RE: Alteration of Terrain Permit Application #250327-055
Jennesstown Manor
Tax Map 7, Lots 39 & 39-1 – Warner

Our office is in receipt of the Alteration of Terrain third request for information comments dated December 16, 2025. Based on the comments, we have made the required modifications and attached revised plans for review. A response to each comment has been provided below.

Alteration of Terrain Application & Stormwater Drainage Analysis

Jennesstown Manor

Routing Diagram for Pre

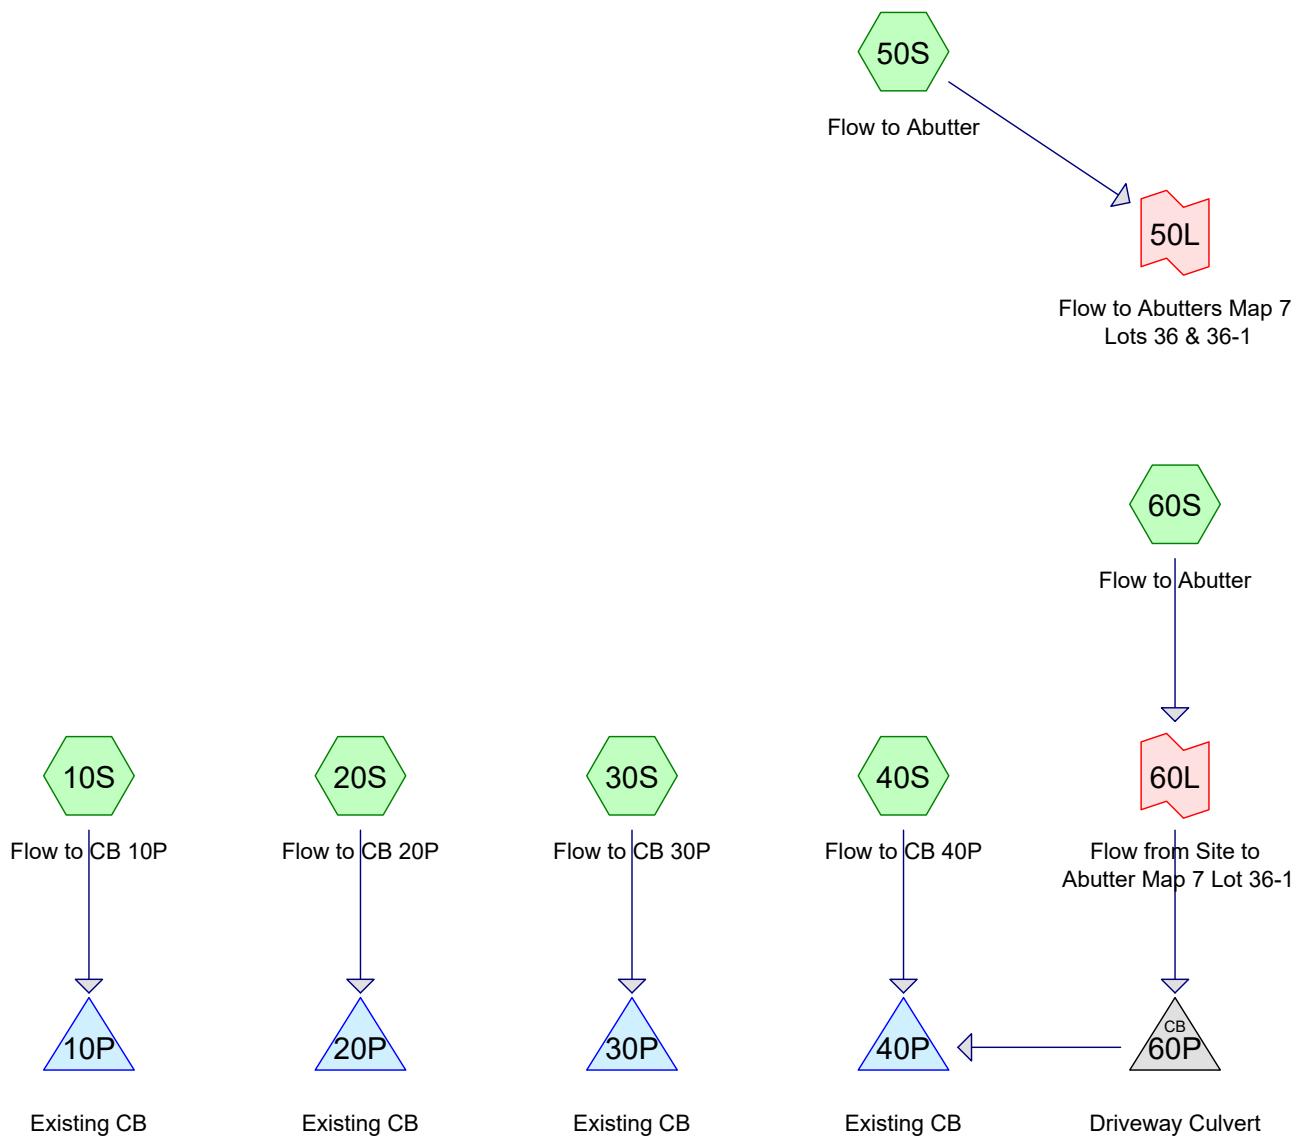
- Provide full version of Section 18. HydroCAD Drainage Analysis as only odd numbered pages were provided.
 - Post-development HydroCAD diagram is only marginally legible.

The full analysis has been provided and the HydroCAD is now a computer generated pdf for legibility.

Routing Diagram for Post

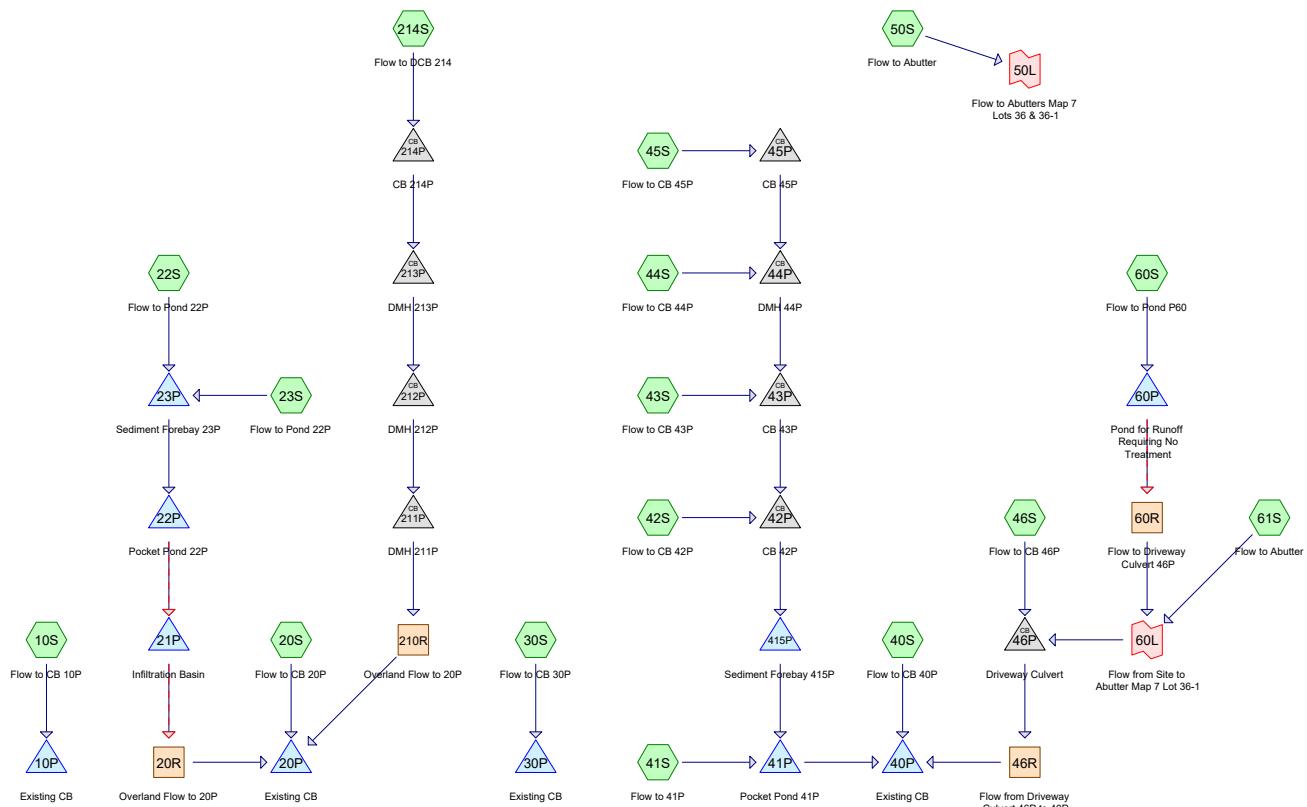
- Define a starting elevation of 471.00 feet for Pond 23P.
- Define a starting elevation of 441.50 feet for Pond 415P.
 - Defining the volume instead with zero percent voids does not account for detention volume above permanent pool in routing. It also results in a Stage-Area-Storage table

The volume for each forebay now has 100% voids and starting elevations at the outlet elevations (471.00 for Pond 23P and 441.50 for Pond 415P). See updated post-development HydroCAD analysis, narrative, riprap calculations, and bmp worksheet attachments.

PRE-DEVELOPMENT DRAINAREAS PLAN

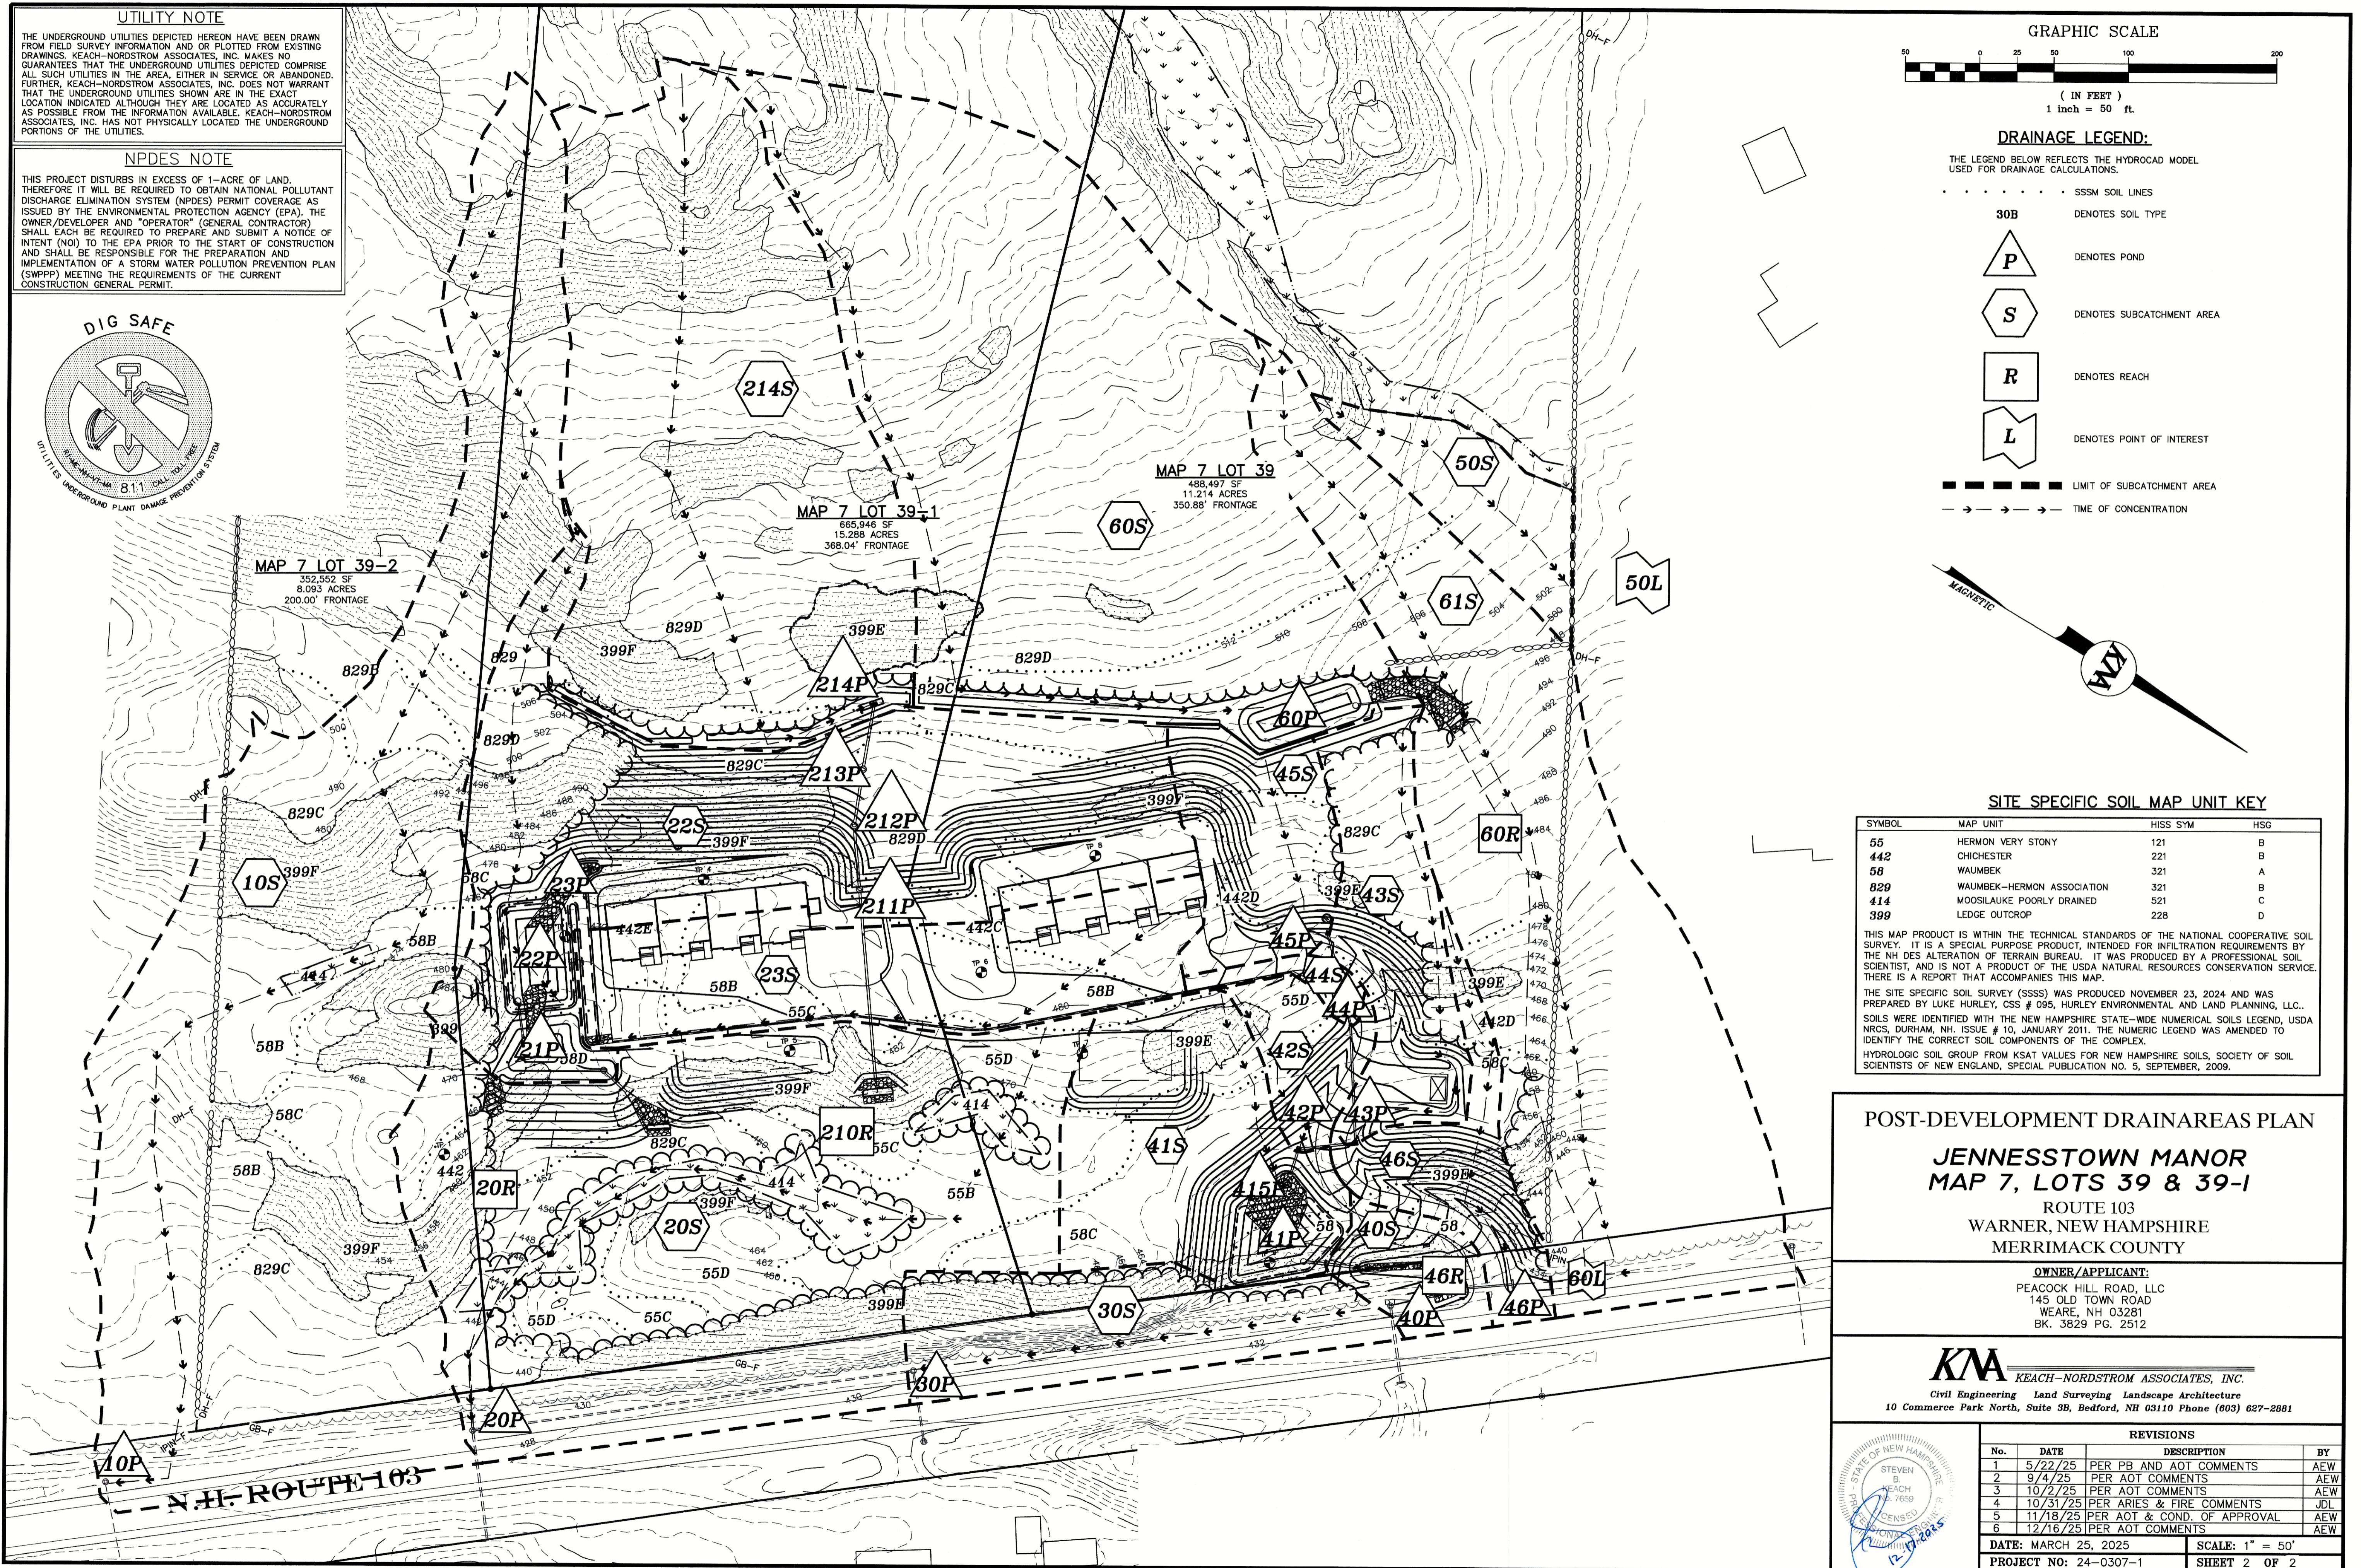
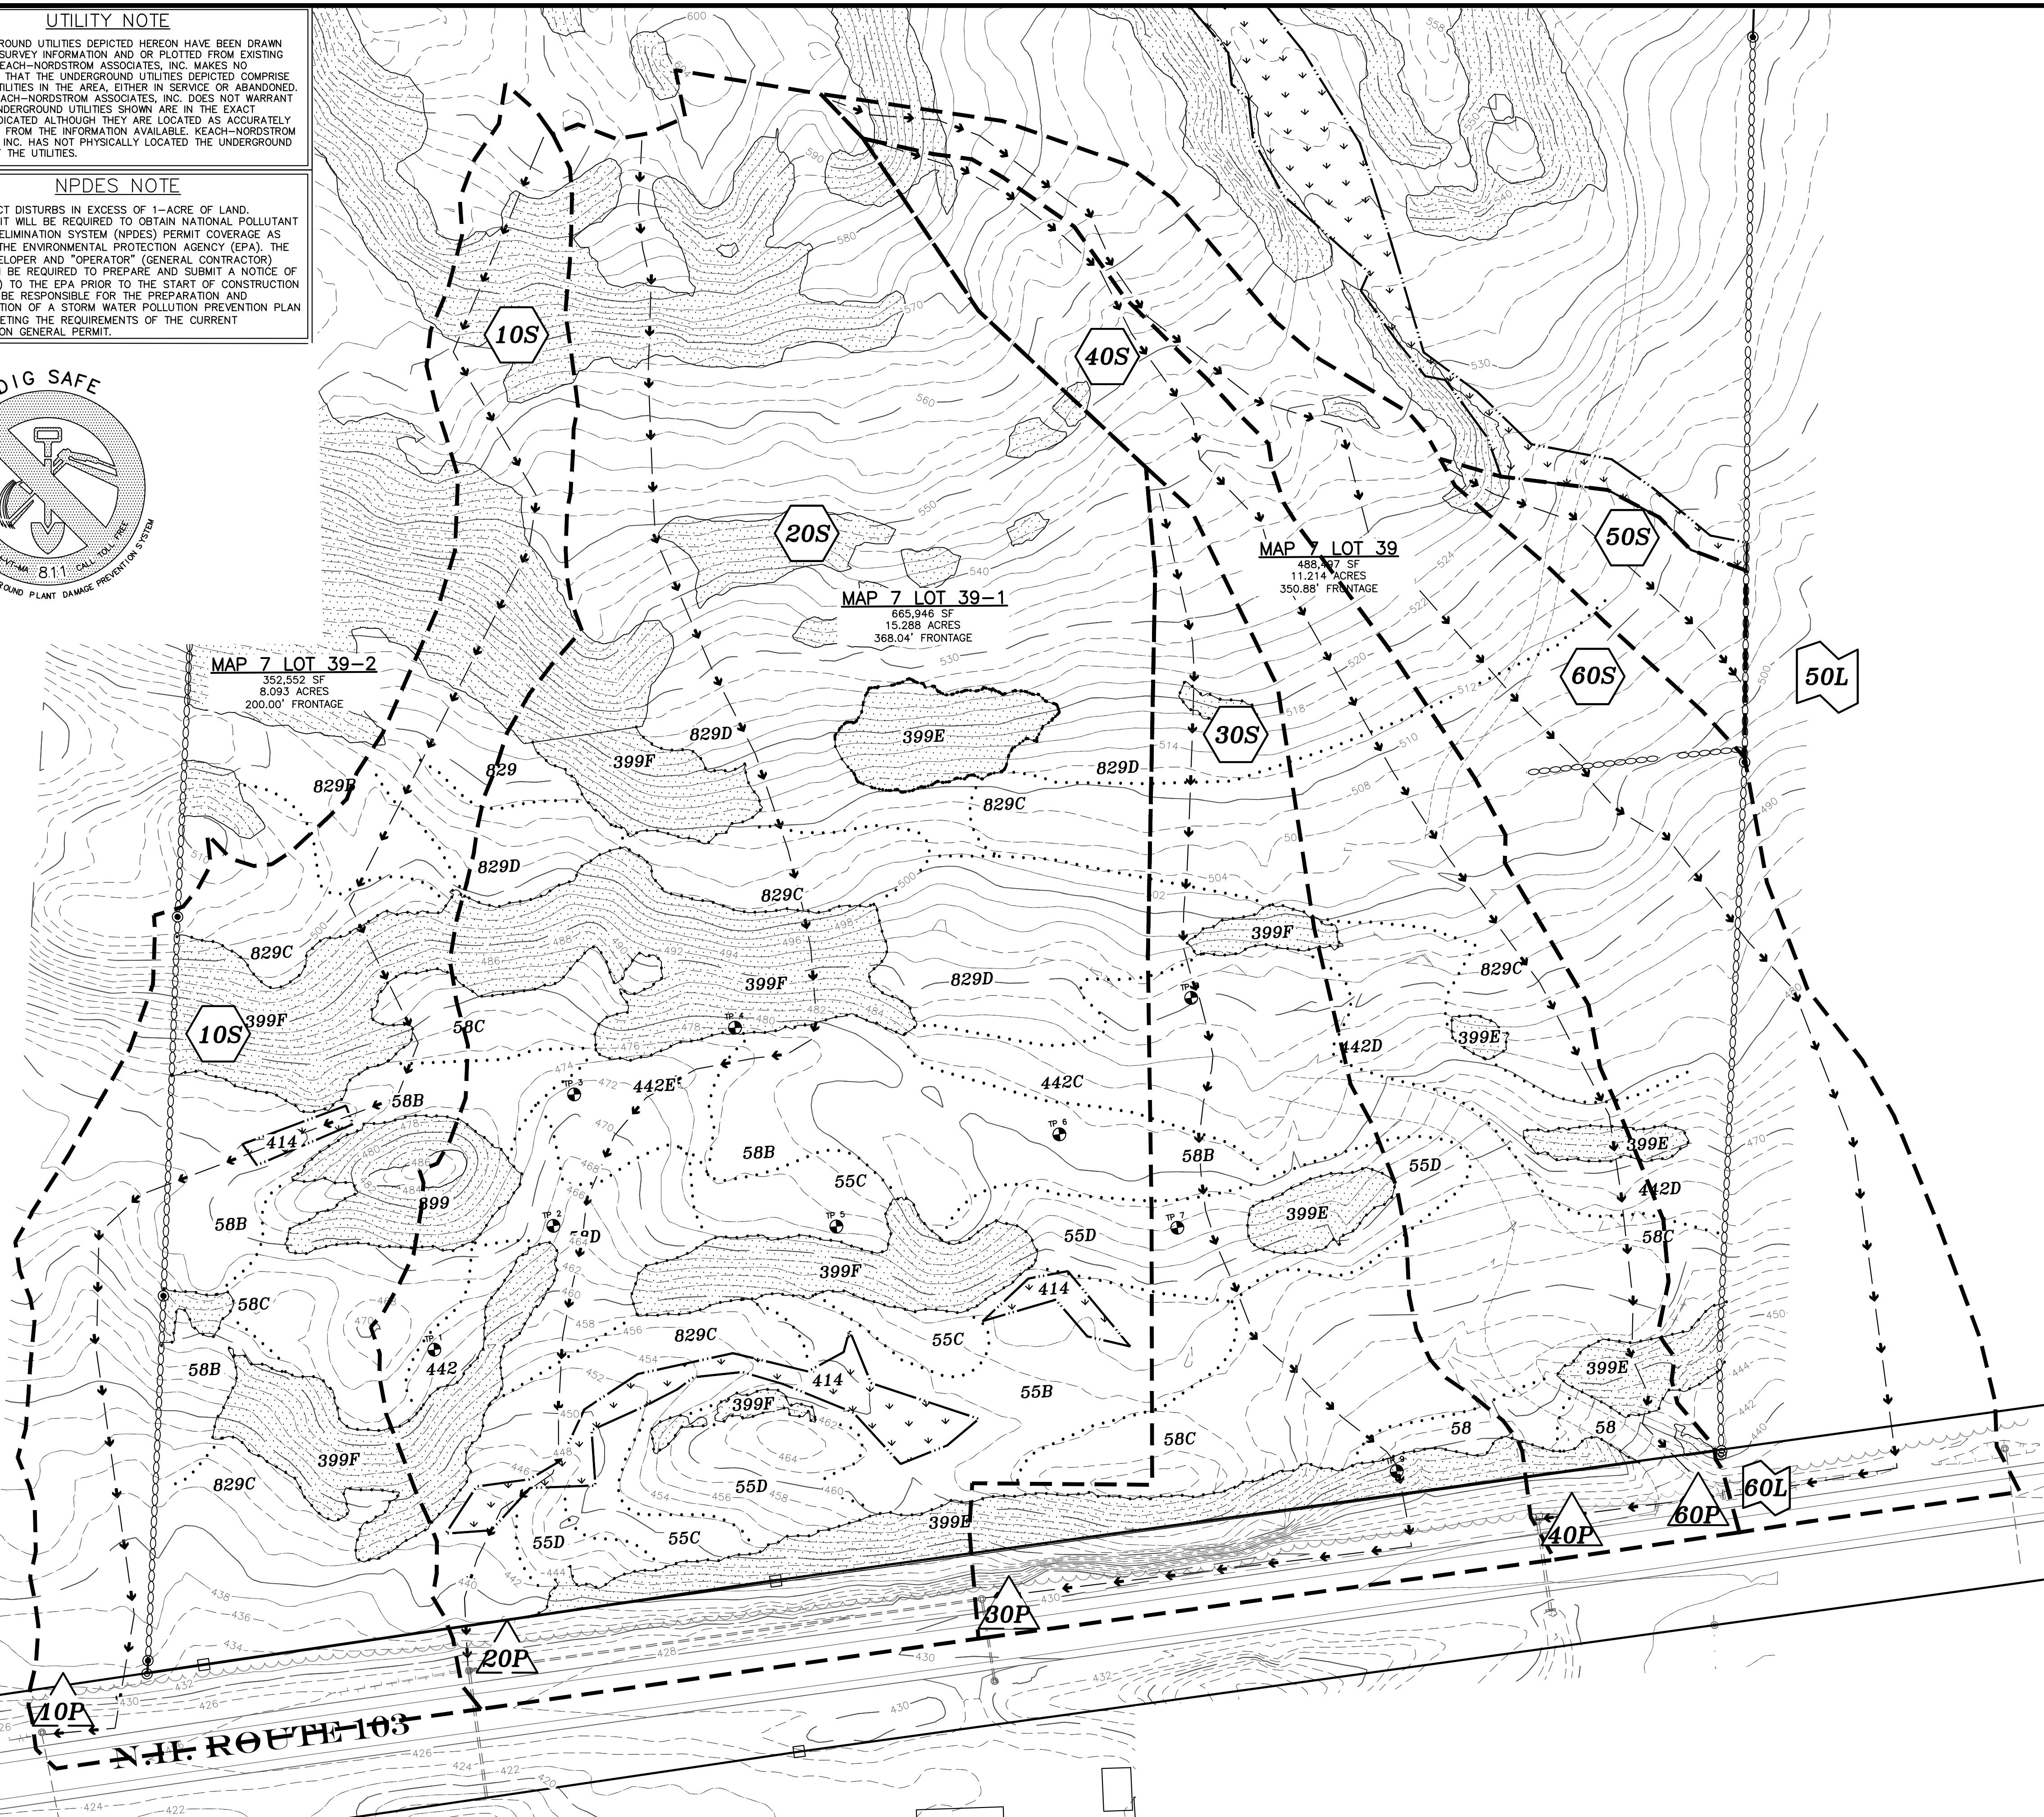
- Provide drainage area plans separate from bound report per Section 11 of application form.

- Plans need to be stamped, signed, and dated by a Professional Engineer (PE) registered in the State of New Hampshire in accordance with Env-Wq 1504.01(e).

Drainage area plans are separate from the bound report as their own file. The pdf contains two copies of the plans: the first is stamped then scanned and the second is computer generated pdfs without stamps.

Drainage and hydrologic soil group plans are now stamped.
